**SUPPLEMENTARY OPINION: VERIFICATION**  
**SOLAR ACCESS AMENITY COMPLIANCE**  
**PROPOSED MIXED USE MULTIRESIDENTIAL BUILDING**  
**229 Miller Street North Sydney**  
**9 September 2016**

1.1.1 In this Supplementary Opinion I review the Applicant's latest amended plans, and submissions relating to solar access compliance. I provide this report in the nature of a probity statement, verifying the accuracy of the analysis, and commenting on the conclusions.

Figure 2: View from the sun at 8.30am

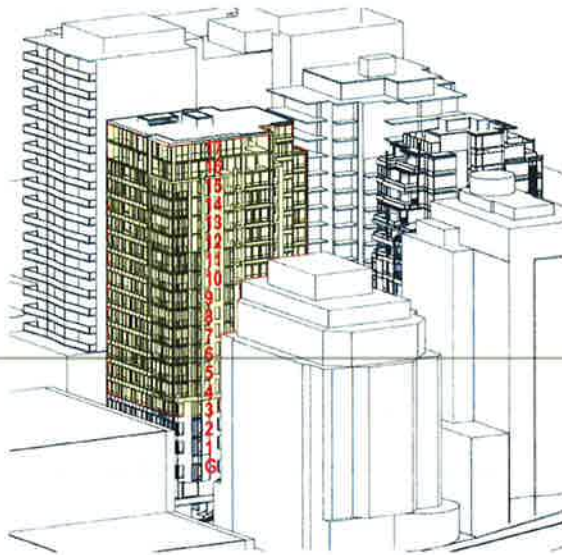
I illustrate the view from the sun at 8:30am in Figure 2. It becomes immediately obvious that the eastern elevation receives its best quality winter solar access in this early morning period.

The view from the sun also illustrates that taking into account the much greater overshadowing of the northern elevation, more of the units in the development will benefit from useful periods of direct sun exposure if oriented to the east elevation.
